# Planning Authority Agenda

## 5.1 Development Application DA 2021 / 00274 - Equipment and Machinery Hire (Storage Containers) at 77 Possum Road, Bridgewater

Applicant:	MCA Architects Pty Ltd
Subject Site:	77 Possum Road, Bridgewater
Proposal:	Equipment and Machinery Hire (Storage Containers)
Planning Scheme:	Tasmanian Planning Scheme - Brighton
Zoning:	General Industrial Zone
Codes:	Signage Code Parking and Sustainable Transport Code Road and Railway Assets Code
Local Provisions:	Brighton Industrial Hub Specific Area Plan Bridgewater Quarry Specific Area Plan
Use Class:	Equipment and Machinery Sales and Hire
Discretions:	Building Height Frontage Setback Landscaping Number of Car Parking Spaces Construction of Parking Areas Pedestrian Access Traffic Generation Design and Siting of Signs Bridgewater Quarry Specific Area Plan
Representations:	One (1) representation was received. The representors raised the following issues: <ul style="list-style-type: none"> <li>• Application is poor quality and unclear</li> <li>• Advertised material does not contain adequate information</li> <li>• Building height</li> <li>• Frontage setback</li> <li>• Landscaping</li> <li>• Signs Code</li> <li>• P

A02. PROPOSED SITE PLAN

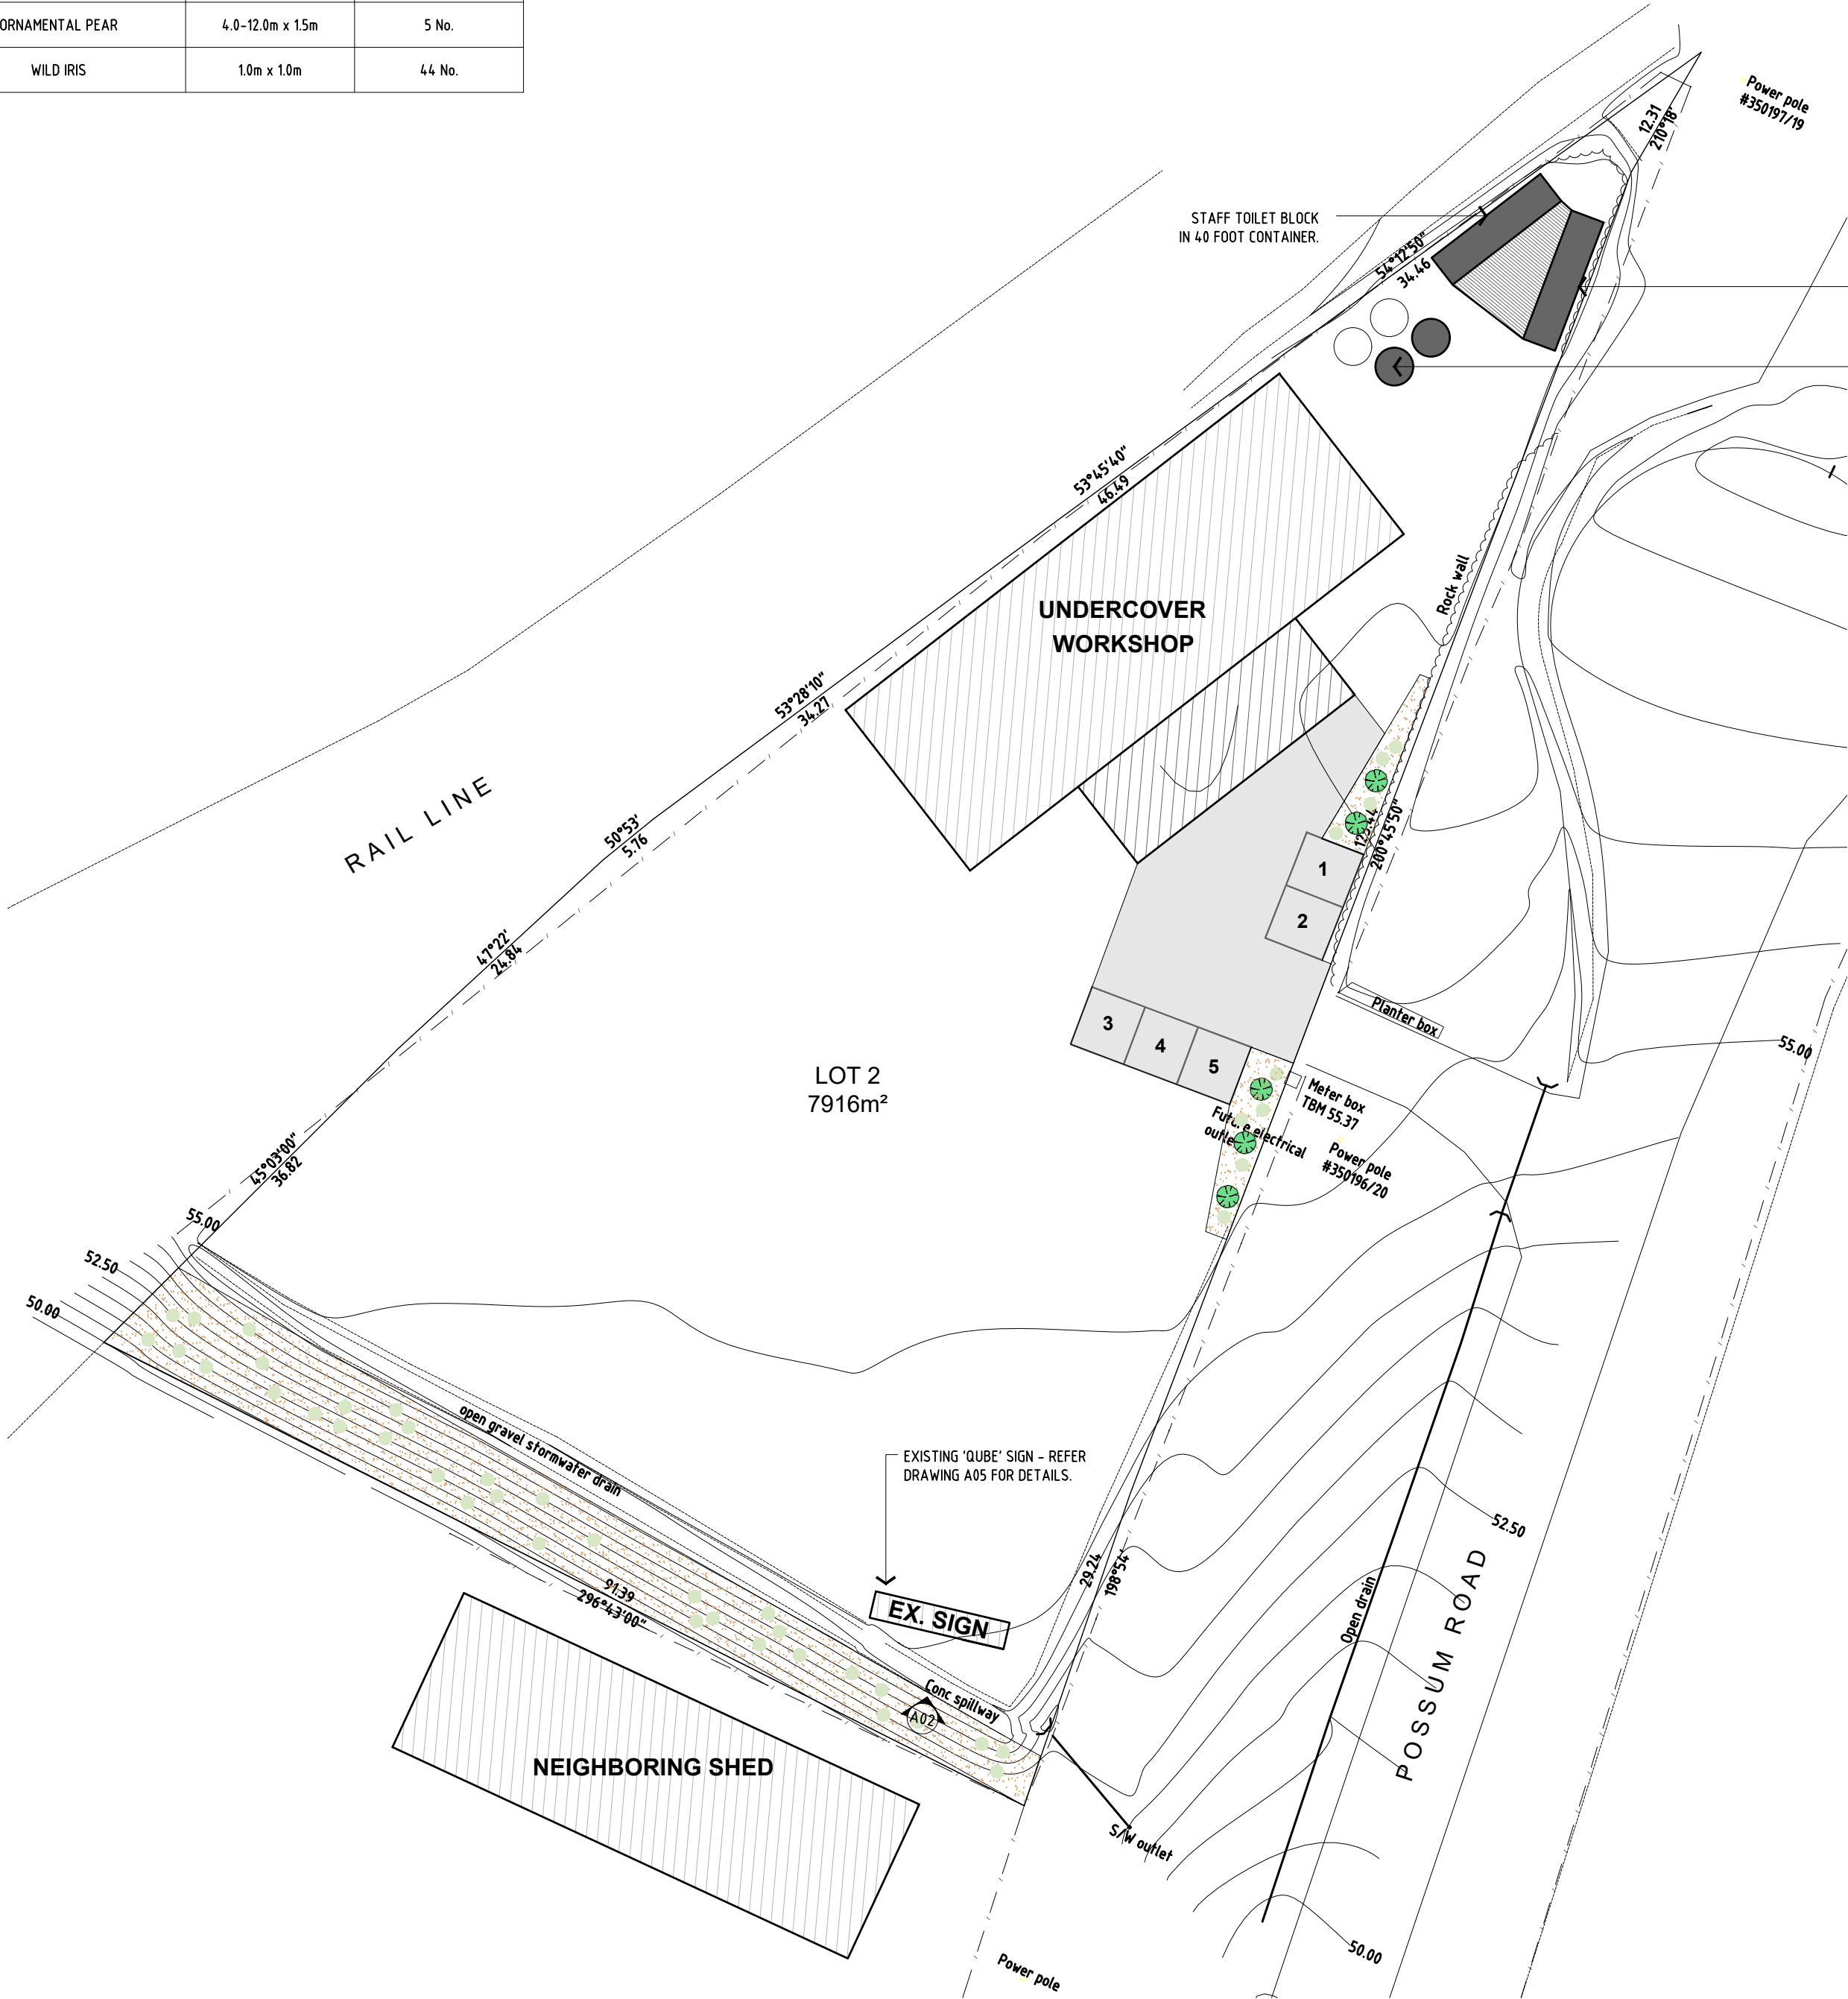
The proposal provides for entry landscaping as shown on sheet A02 of the proposal documents. The proposed landscaping does not satisfy the acceptable solution, therefore assessment against the performance criteria is relied upon.

The setback has a variable width, being approximately 3m along the southern portion of the frontage boundary, adjacent to the stacked containers, and will be further reduced in the northern point of the lot, as shown on Site Plan A02.

The site plan at A02 shows proposed landscaping to be in the form of five (5) Ornamental Pear trees (*Pyrus Calleryana*) and low lying shrubs, being Wild Iris (*Dietes Grandiflora*)x44.

It is considered that for the proposal to satisfy the performance criteria, conditions can be included in any permit approved, requiring an amended landscaping plan prepared by a suitably qualified person to be provided, and for the landscaping to be implemented within a specific period of time. The amended landscaping plan should show:

- a) Landscaping extended to the northern edge of the access, through the increased setback/relocation of the car stackers labelled 1 and 2;
- b) The Landscaping shown on plan "A02. Proposed Site Plan" tapered from five metres (5m) either side of the access to a depth of two metres (2m) long the entire Possum Road frontage, except where it tapers to accommodate the office block/kitchenette. The landscaping should consist of a mix of mature trees, hedges and ground covers/shrubs to enhance the visual amenity of the site, preferably hardy native species suitable for an industrial area. Mature trees must be a minimum height of 1.5m at the time of planting.
- c) A planting schedule of all proposed trees, shrubs and ground covers including botanical names, common names, pot sizes, sizes at maturity and quantities of each plant.

4. Within one (1) month of the date of this permit, an amended Site plan must be submitted showing:
  - a. stackers 1 and 2 relocated to allow for the landscaping to be extended to the northern edge of the access; and
  - b. containers setback a minimum of three (3) metres from the Possum Road frontage to accommodate the landscaping required by condition 13.

13. Within one (1) month from the date of this permit, an amended landscaping plan prepared by a suitably qualified person must be submitted to, and approved by, Council's Manager Development Services. The amended plan must show:

- a) Landscaping extended to the northern edge of the access as per condition 3.
  - b) The Landscaping shown on plan "A02. Proposed Site Plan" tapered from the landscaping as shown on either side of the access to a minimum depth of two (2) metres along the entire Possum Road frontage, except where it abuts the office/kitchen building. The landscaping should consist of a mix of mature trees, hedges and ground covers/shrubs to enhance the visual amenity of the site, preferably hardy native species suitable for an industrial area. Mature trees must be a minimum height of 1.5m at the time of planting.

A03. EXISTING PLAN / ELEVATIONS / SIGNAGE 1:200

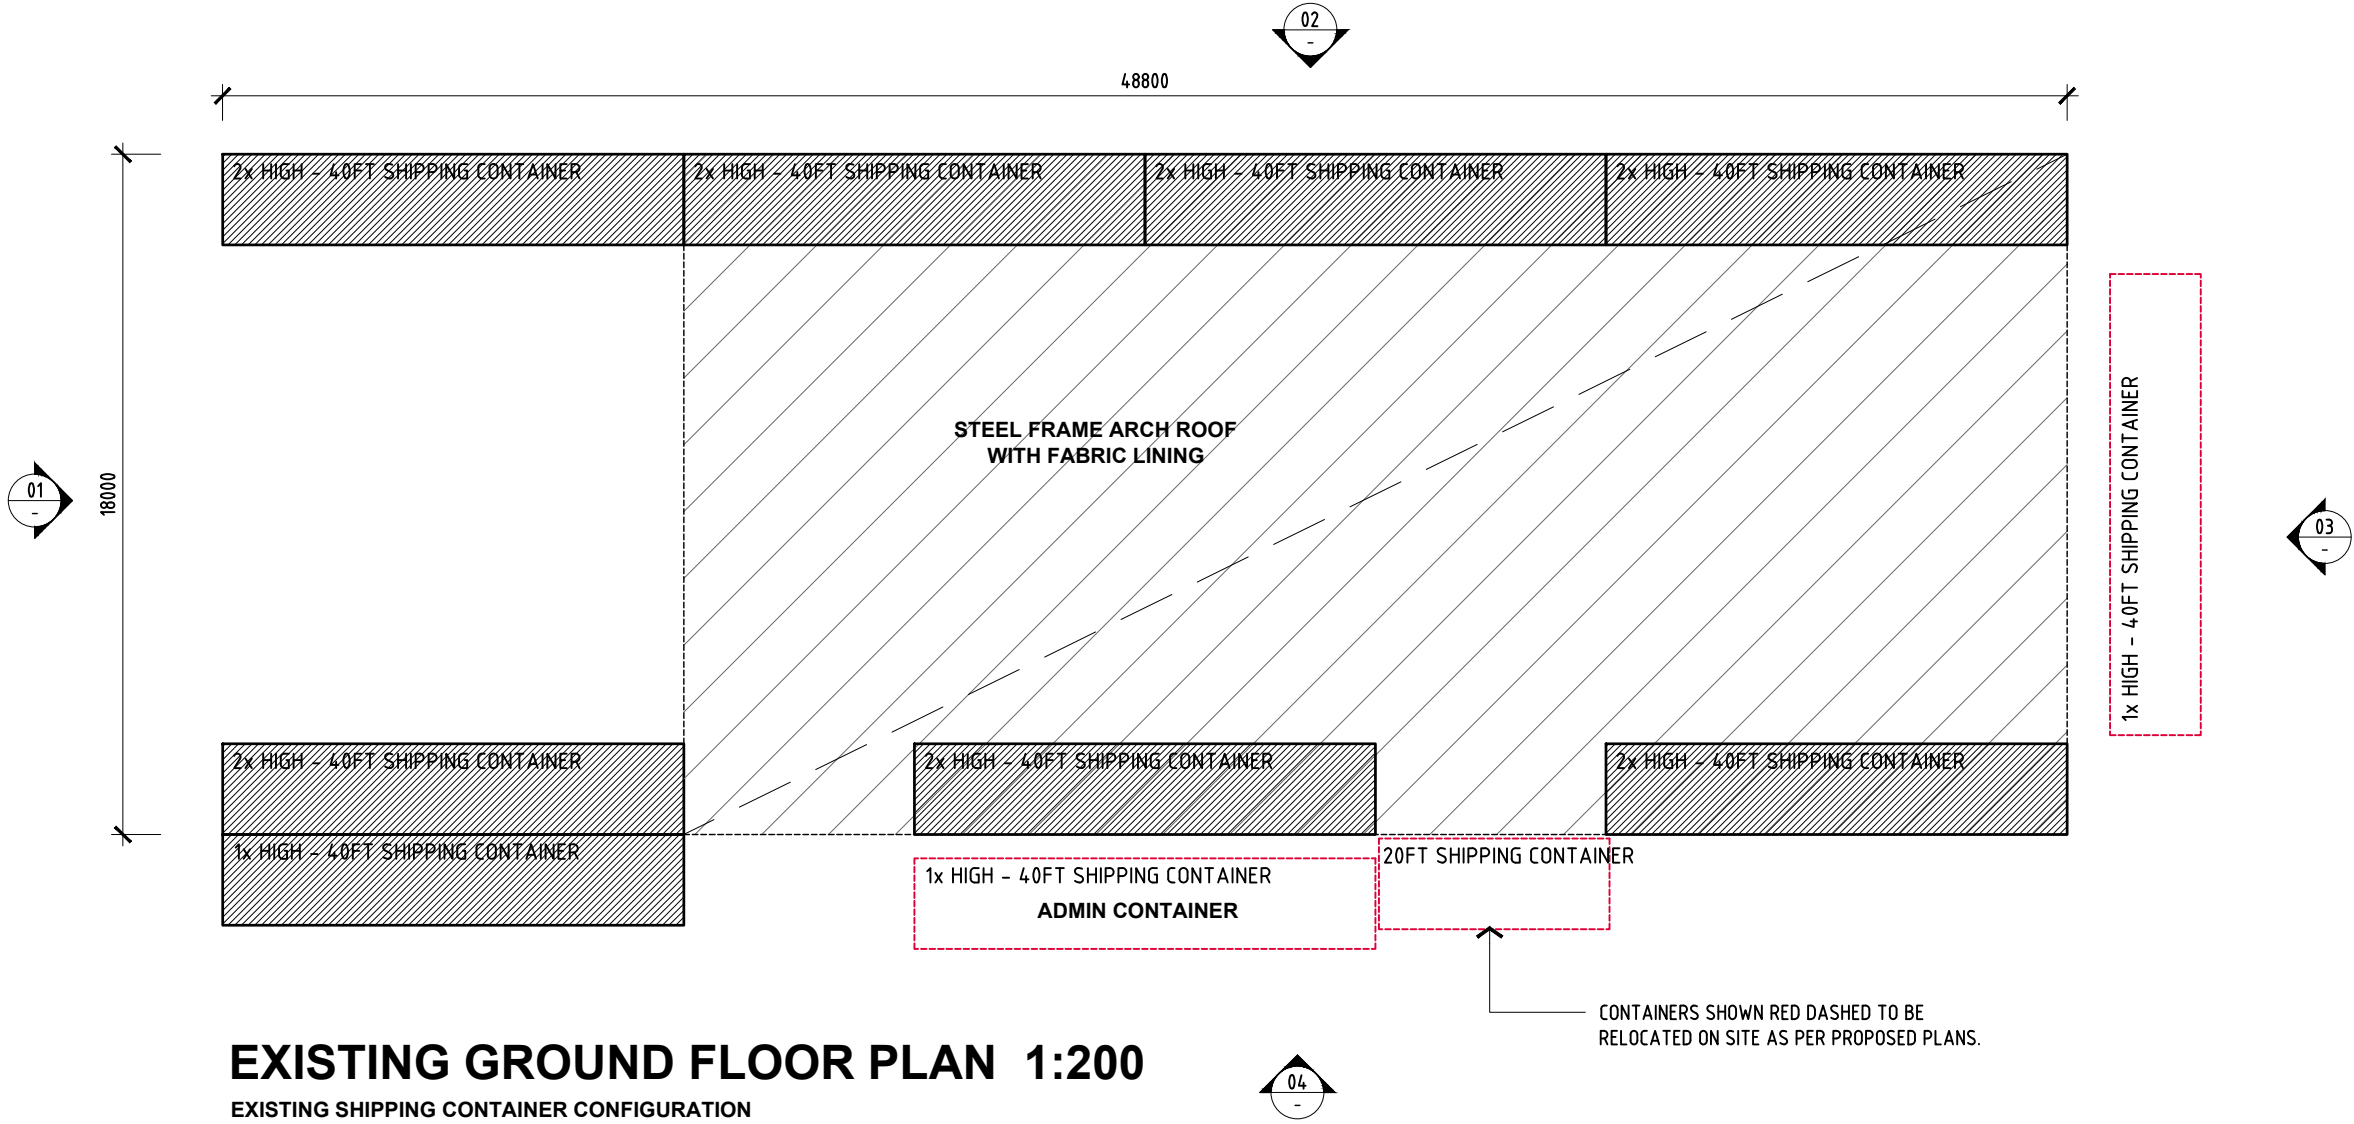
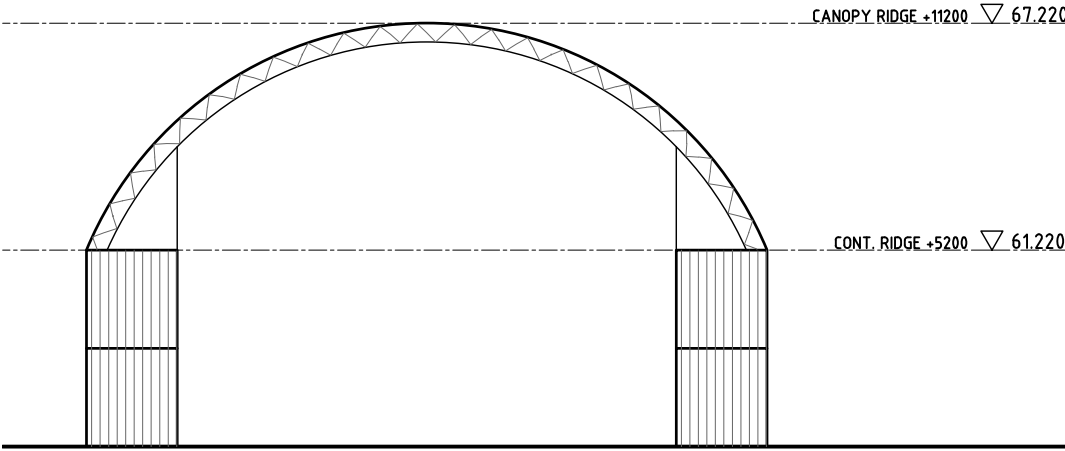
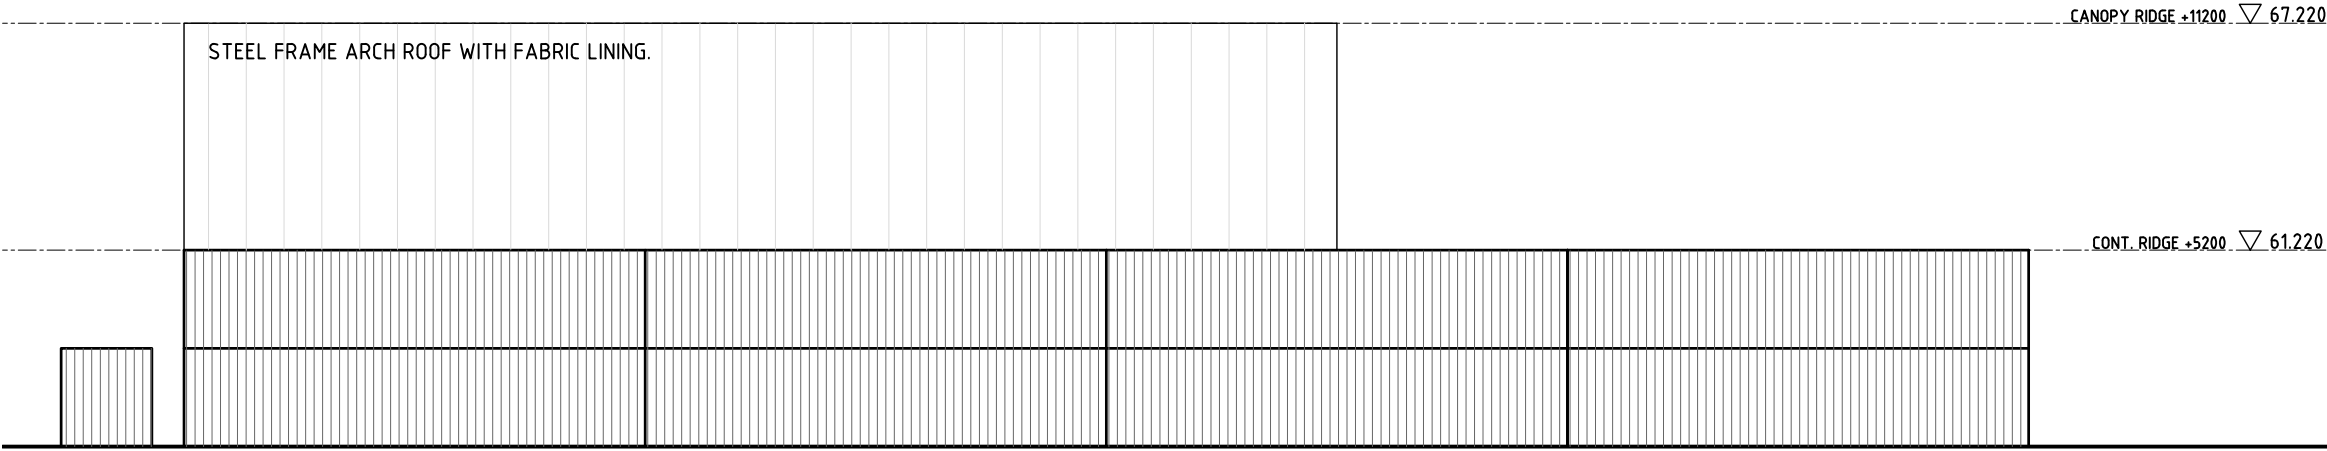
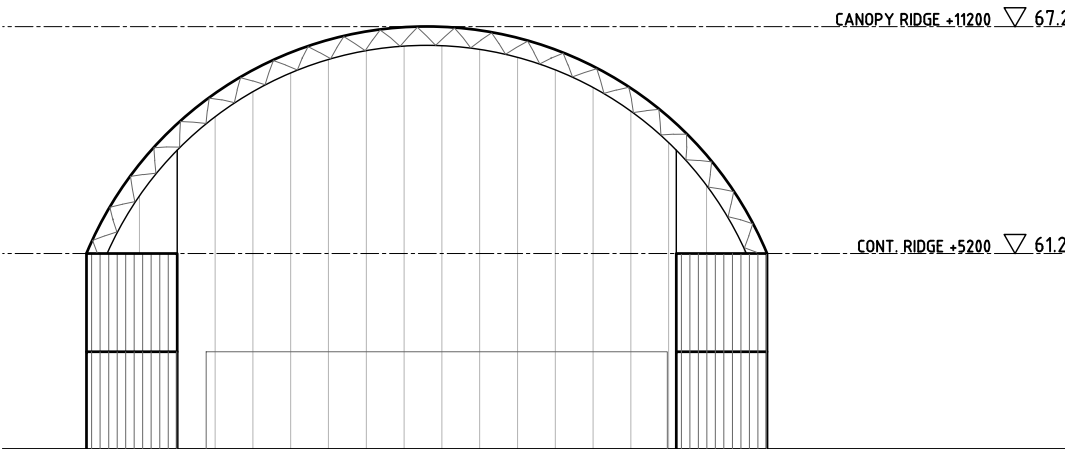
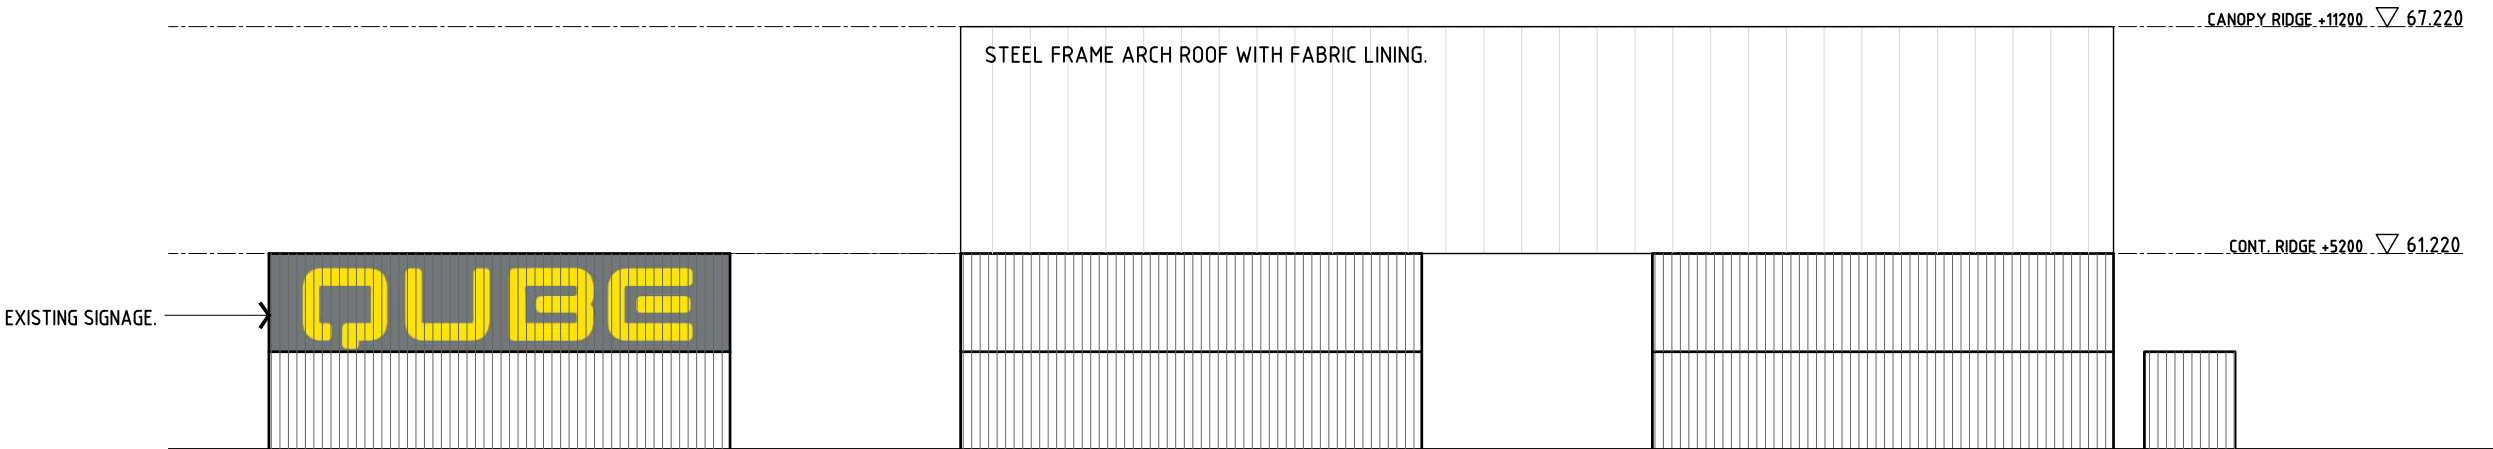
The proposal provides for the following wall signage (as shown on Sheet A03 (replicated on A04 and A05):

- On two stacked 40 foot shipping containers located in the southern corner of the site (existing) (refer "existing signage 1:200" on top left corner of sheet A03)
- On a 40 foot shipping container forming part of the south eastern corner of the covered workshop, one shipping container above ground (refer elevation 04 on sheet O3)
- "New Printed shade cloth signage to be attached to existing cyclone fencing the length of the boundary facing Possum Street" (refer bottom of sheet A05)
